UNITED STATES PATENT AND TRADEMARK OFFICE

APPLICATION NO.	FILING DATE	FIRST NAMED INVENTOR	ATTORNEY DOCKET NO.	CONFIRMATION NO.
10/689,001	10/20/2003	Gayatri Vyas	8540G-236COA	4101

Office Action Summary

DETAILED ACTION

FIG. 1

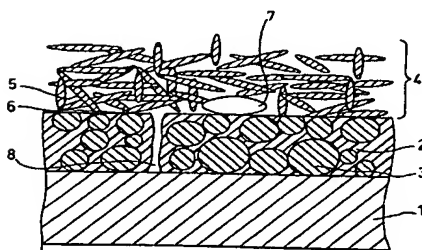
1st approach: it is imperative to note that the electroconductive resin layer incorporates therein an electroconductive particulate substance (COL 4, lines 5-15) and powders of metal oxide such as Ru-oxide are effective as the electroconductive particulate substance (COL 4, lines 15-21). As depicted in **Figure 1** below, electro-conductive particles 3 are dispersed in the electroconductive resin layer 2 and direct contact gas diffusion electrode 4 (See Figure 1/ COL 6, lines 12-30). Thus, Ru-metal oxide particles directly contact the electrode 4.

FIG. 1

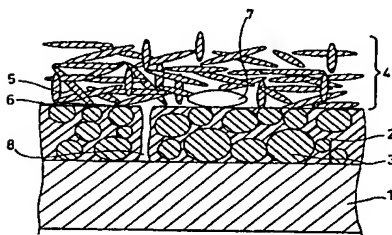
1st approach: in this respect, (*emphasis supplied* →) it is imperative to note that electroconductive resin layer 2 incorporates therein an electroconductive particulate substance (COL 4, lines 5-15) and powders of metal oxide such as Ru-oxide are effective as the electroconductive particulate substance (COL 4, lines 15-21). As depicted in **Figure 1** below, electro-conductive particles 3 are dispersed in the electroconductive resin layer 2 and direct contact gas diffusion electrode 4 (See Figure 1/Col 6, lines 12-30). Thus, Ru-metal oxide particles directly contact the electrode 4.

contributes to the position taken by the examiner because the oxide is formed on the surface of the metal substrate 1 facing the gas diffusion electrode 4. Accordingly, reactant gas diffuses through pinhole 8 in the resin layer 2 and contacts the oxide layer deposited between the resin layer 2 and the metal substrate 1. Since the oxide layer prevents contact between the reactant gas and the metal substrate, it can be said that the oxide layer is acting as a direct barrier therebetween. Meanwhile, the oxide layer per is in direct contact with the reactant gas, and therefore in communication therewith.

Stated alternatively, Gyoten et al teach that the oxide layer is situated between the metal substrate 1 and said electroconductive resin layer 2 (COL 8, lines 48-52/CLAIM 2). Notice also the presence of pin-hole 8 and gas diffusion electrode 4 (See FIGURE 1/COL 6, lines 12-30). Given that pin-hole 8 directly provides an open path therebetween, it can be said that reactant gas diffusing through gas diffusion electrode also diffuses through the electroconductive resin layer 2. Therefore, said reactant gas contacts or communicates with the oxide layer placed between the metal substrate 1 and said electroconductive resin layer 2.
